Access Audit Final Site Report

Lions Park
110 W Camp McDonald Rd
Prospect Heights, IL 60070

Inspection Date: 02/29/2024
Inspectors: Shelley Zuniga

Prepared By
WT Group

Finding: 2

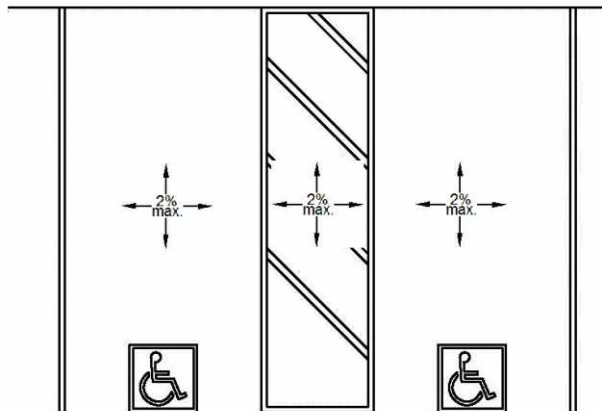
The cross slopes (narrow dimension) and/or running slopes (long dimension) of the access aisle exceeds 2%.

baseball aisle - 2.8%
slope; right aisle at
tennis - 2.9%

Repair or correct slope of parking space and access aisle to max 2.08% in any direction.

Finding: 3

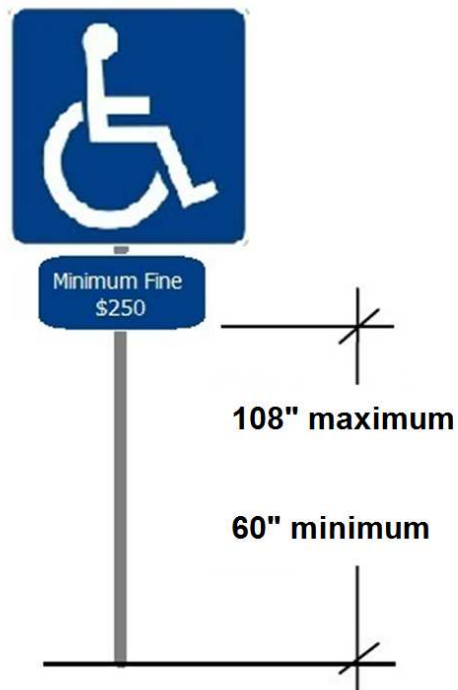
The parking sign is mounted too low.

baseball stall - sign at 48"; tennis stalls - 48" and 49"

Raise existing accessible parking signs so lowest end of bottom sign is min 60" aff and max 108" aff

Finding: 4

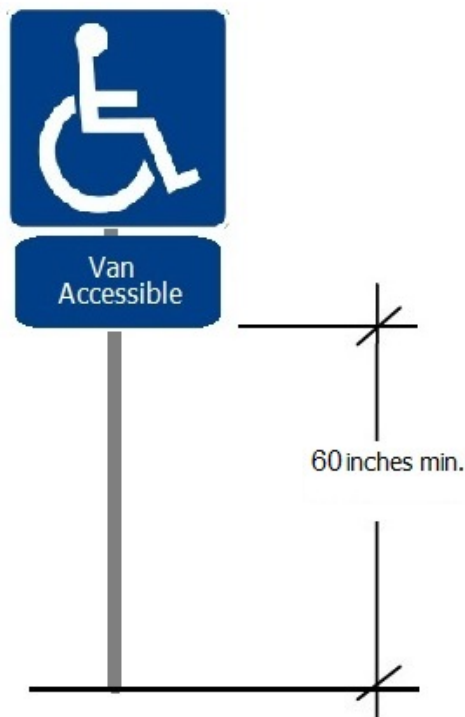
The van stall is missing a sign identifying it as a van accessible stall.

van sized stalls lack
van sign

Add one van parking sign to one accessible stall and ensure stall and access aisle are 11' and 5' or 8' and 8'.

Finding: 6

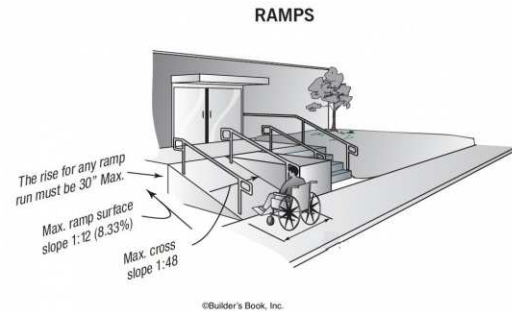
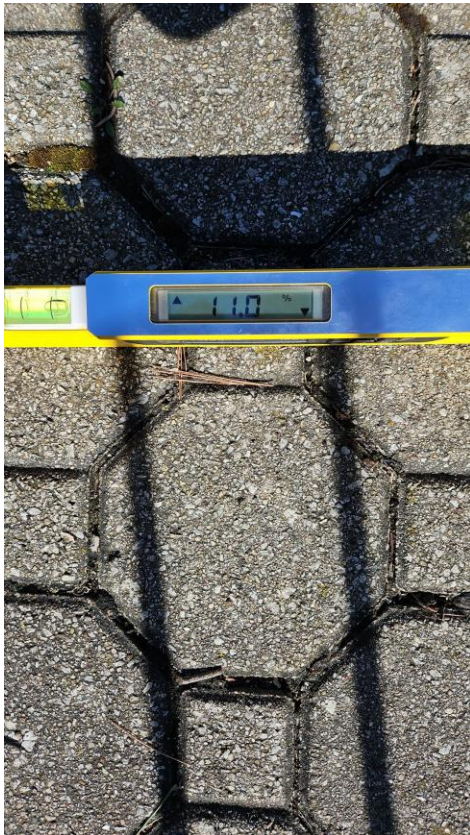
The ramp slope exceeds the maximum running slope (direction of travel) allowable of 8.33%.

Ramp to shelter - 11%
running on second run

Correct slope of ramp to max 8.33%

Finding: 7

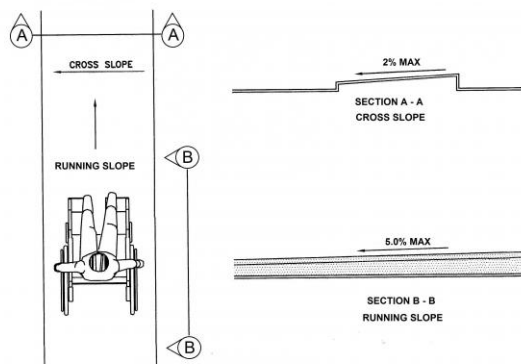
The ramp on the accessible route contains cross slopes greater than 2%.

Ramp to shelter -
cross slopes: 2.9% at
top of first run, 5.4%,
20.2% on second run,
4.5% at top near
shelter

Correct ramp cross slope to max 2.08%

Finding: 8

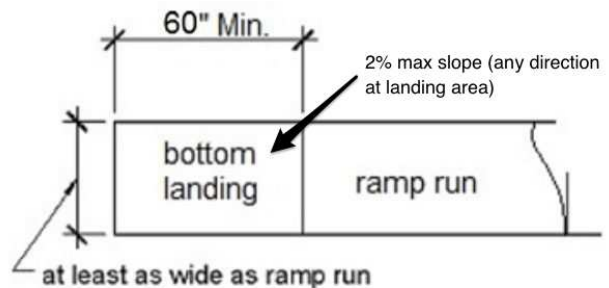
The landing at the bottom of the ramp has a slope greater than 2%.

Ramp to shelter - 2.7%
at first landing, 6.3%
bottom landing

Correct ramp landing slope to max 2.08%

Finding: 9

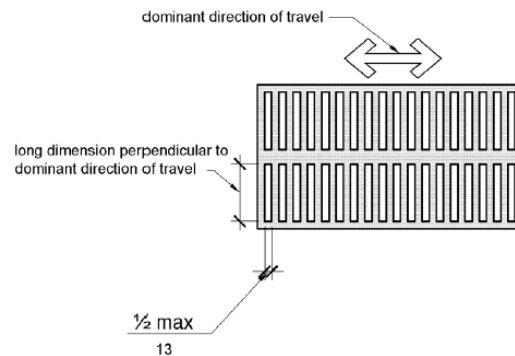
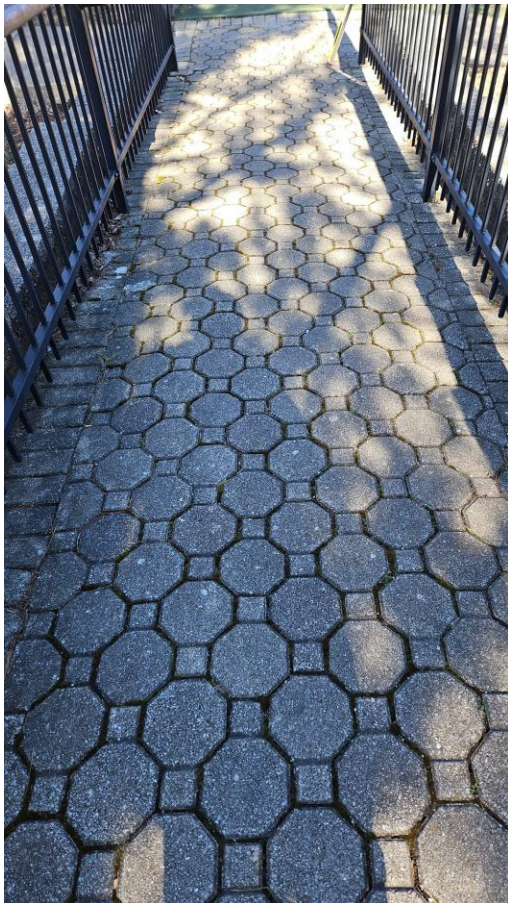
Ramp to shelter -
pavers in disrepair,
recommend full redo

See previous findings for corrections to all runs and landings of ramp.

Finding: 10

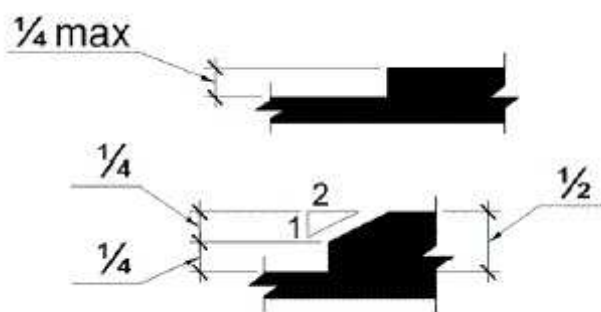
There is a change in level greater than 1/4 inch.

Ramp to shelter -
sinking pavers create
CIL

Repair, bevel or ramp CIL along accessible route (AR) to max .25". Reset pavers, or create ramp out of a more stable material. Cost is previous findings.

Finding: 11

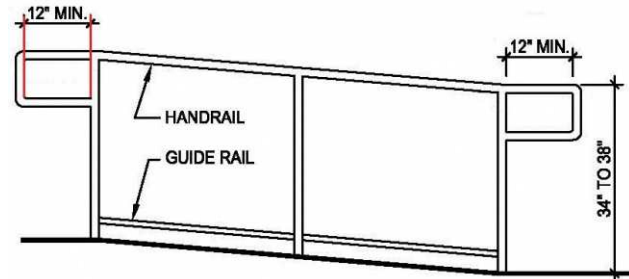
The ramp does not have compliant handrails.

Ramp to shelter -
handrail on one side
only

Install handrails that are rounded and/or extend to the ground, with handrail extensions and mounted 34" to 38" aff

Finding: 12

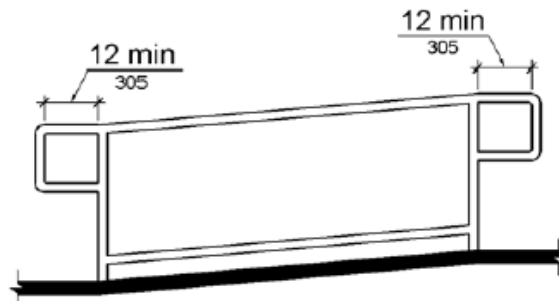
The handrail is not continuous the entire length of the ramp.

Ramp to shelter - lack top and bottom extensions

Replace existing handrail with one that is continuous along the full length of the ramp and having required top and bottom extensions.

Finding: 13

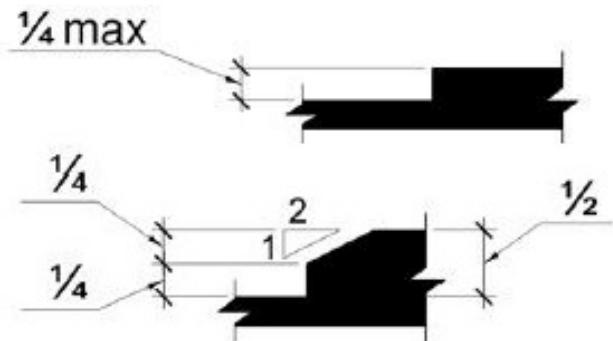
The walkway contains abrupt vertical edges and/or variations over a 1/4 inch.

1" CIL from walk to pavers at play area

Repair, bevel or ramp change in level along accessible route.

Finding: 16

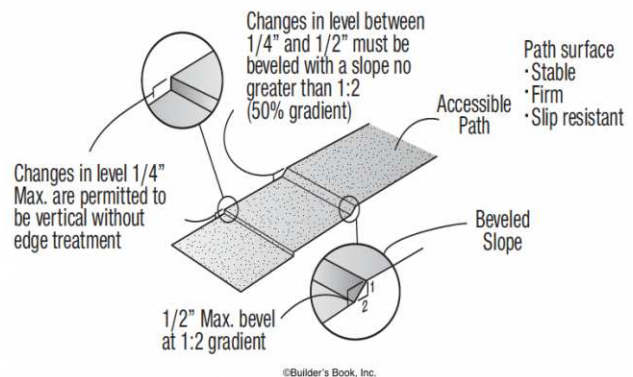
The surface of the curb ramp is not firm, stable and/or slip resistant..

deterioration at curb
ramp from parking to
play area

Redo ramp to provide firm, stable and slip resistant surface.

Finding: 17

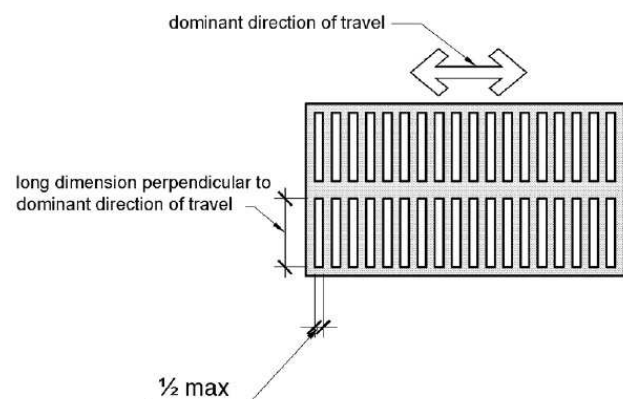
There is a gap spaced greater than a 1/2 inch.

1" gap along tennis parking

Correct or fill gaps to be max .5".

Finding: 18

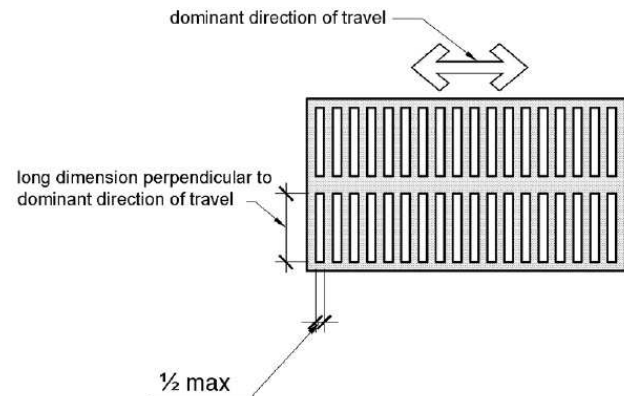
There is a gap spaced greater than a 1/2 inch.

1" gap at tennis path

Correct or fill gaps to be max .5".

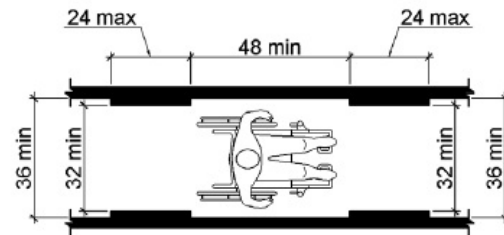
The route of travel at this location does not provide the required minimum width.

route to shelter
reduces to 24" due to
mud runoff

Maintain route to min 36" clear width.

Finding: 20

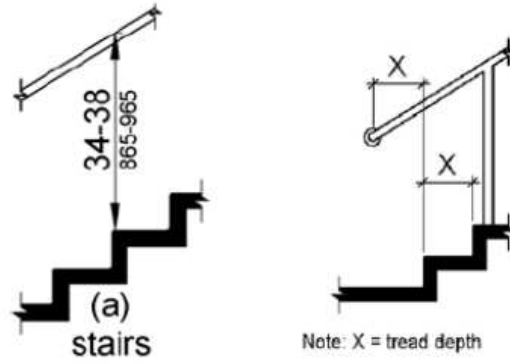
Stairways must have handrails on both sides.

steps from tennis to shelter lack handrail on one side, existing handrail fails to have compliant extensions

Install handrails on both sides of stairway, mounted 34" to 38" aff with top and bottom extensions and having a 1.25" – 2" in diameter, or a non-circular grip that has a perimeter dimension of 4"- 6.25" max with a min gap of 1.5" between handrail and wall

Finding: 22

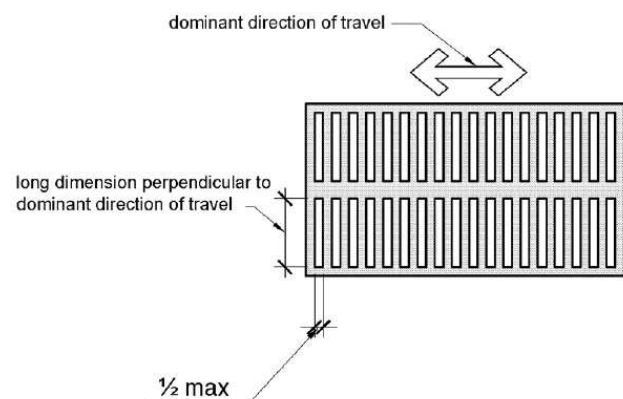
There is a gap spaced greater than a 1/2 inch.

1" gap from tennis to shelter

Correct or fill gaps to be max .5".

Finding: 23

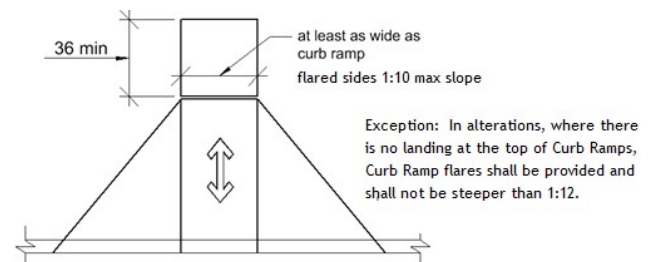
The curb ramp does not have a compliant top landing and the side flares are too steep.

Ramp near baseball stall - right flare 13.2%

Correct slope of side flares to max 8.33%

Finding: 24

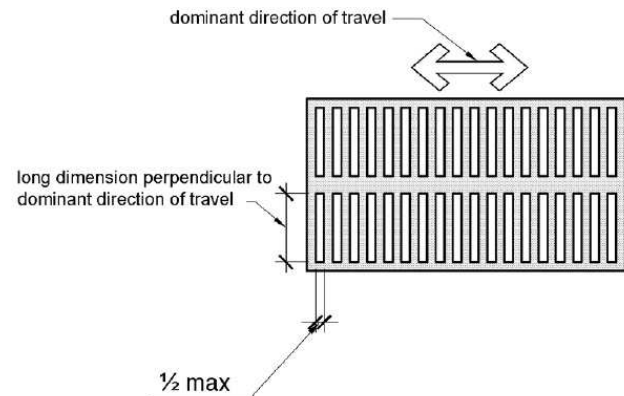
There is a gap spaced greater than a 1/2 inch.

four 1.5" and 3" gap
from tennis parking to
play area

Correct or fill gaps to be max .5".

Finding: 27

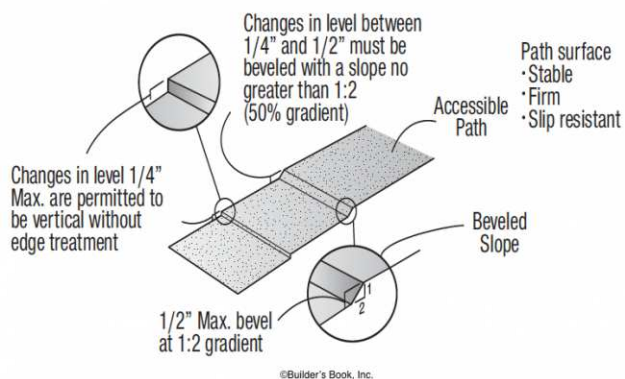
The surface of the curb ramp is not firm, stable and/or slip resistant..

Ramp near baseball
stall - gutter
deterioration

Repair curb ramp to be firm, stable and slip resistant.

Finding: 28

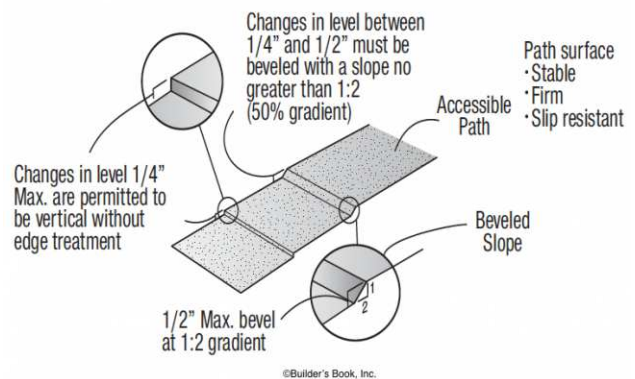
The accessible route contains loose gravel and/or surfaces that do not provide for a stable, firm slip resistant surface.

deterioration at
drainage pipe near trail

Resurface accessible route where deterioration occurs.

Finding: 29

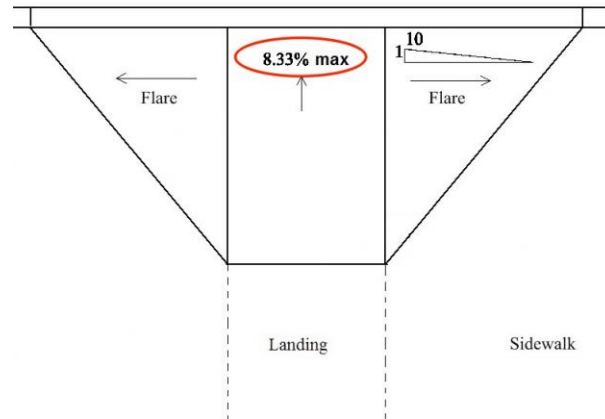
The curb ramp slope exceeds the maximum running slope (Parallel to the direction of travel) allowable of 8.33%.

curb ramp to play area
- 8.6% slope

Correct curb ramp running slope to max 8.33%

Finding: 30

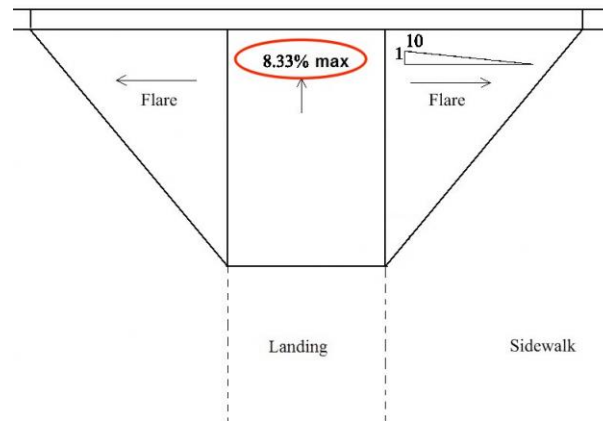
The curb ramp slope exceeds the maximum running slope (Parallel to the direction of travel) allowable of 8.33%.

curb ramp to story trail
- 13% slope

Correct curb ramp running slope to max 8.33%

Finding: 31

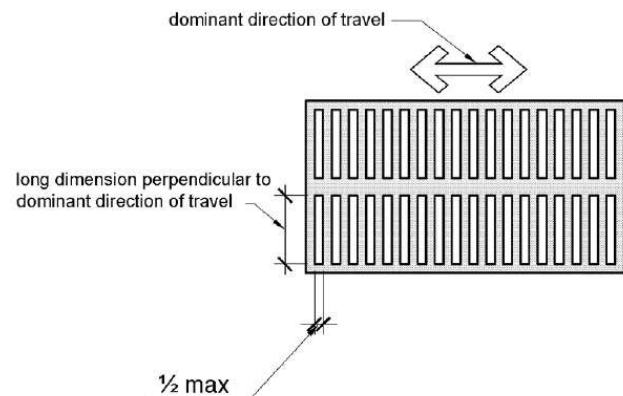
There is a gap spaced greater than a 1/2 inch.

three 1" gap from
baseball to trail

Correct or fill gaps to be max .5".

Finding: 33

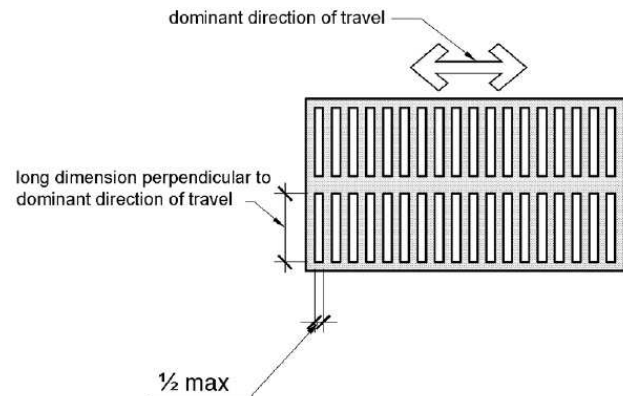
There is a gap spaced greater than a 1/2 inch.

2" gap between asphalt and concrete where maintenance vehicles parked

Correct or fill gaps to be max .5".

Finding: 35

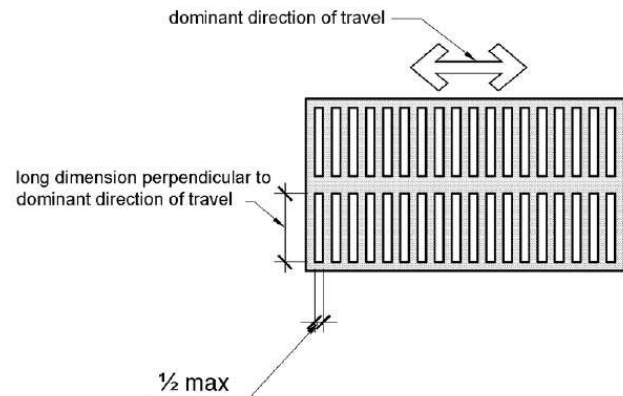
There is a gap spaced greater than a 1/2 inch.

1.75" gap near ball field stall

Correct or fill gaps to be max .5".

Finding: 36

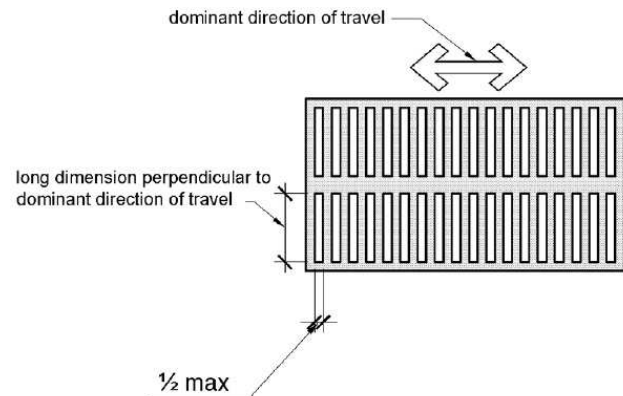
There is a gap spaced greater than a 1/2 inch.

2" gap at corner ramp
near ball field stall

Correct or fill gaps to be max .5".

Finding: 37

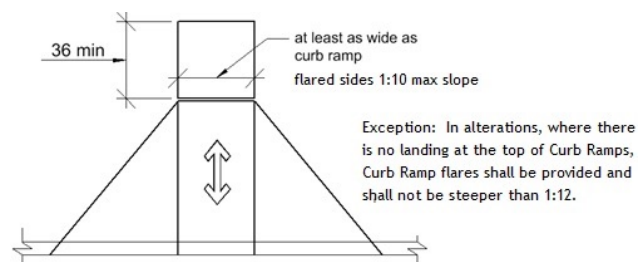
The curb ramp does not have a compliant top landing and the side flares are too steep.

12.7% side flare at corner ramp near ball field stall

Correct slope of side flares to max 8.33%

Finding: 39

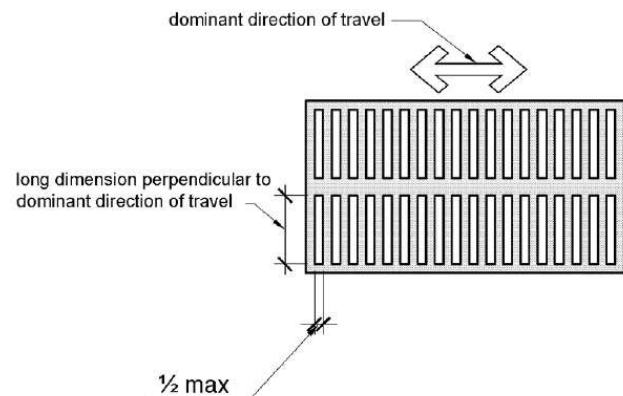
There is a gap spaced greater than a 1/2 inch.

2.25" gap from ball field parking to building, .75" along building, .75" at joint, 2.25" near stop sign

Correct or fill gaps to be max .5".

Finding: 40

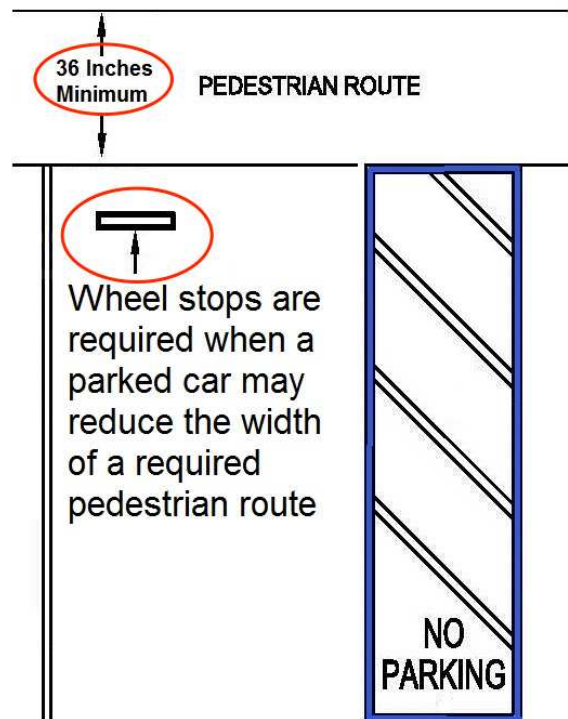
Parked vehicles shall not reduce the required width of the accessible route.

parked vehicles
overhang accessible
route from ball field
stall to story walk trail

Install wheels stops at parking stalls along the AR to prevent vehicles from overhanging into the clear width of the AR

Finding: 42

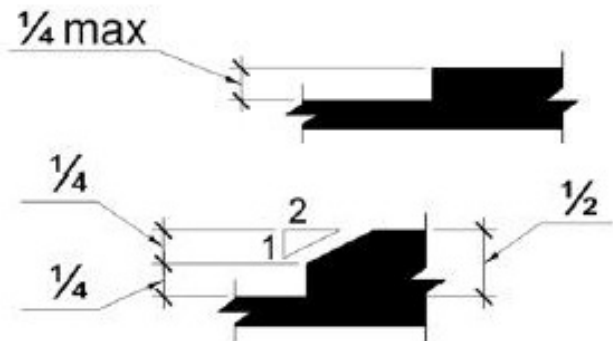
The walkway contains abrupt vertical edges and/or variations over a 1/4 inch.

1.25" CIL at area where maintenance vehicles park

Repair, bevel or ramp change in level along accessible route.
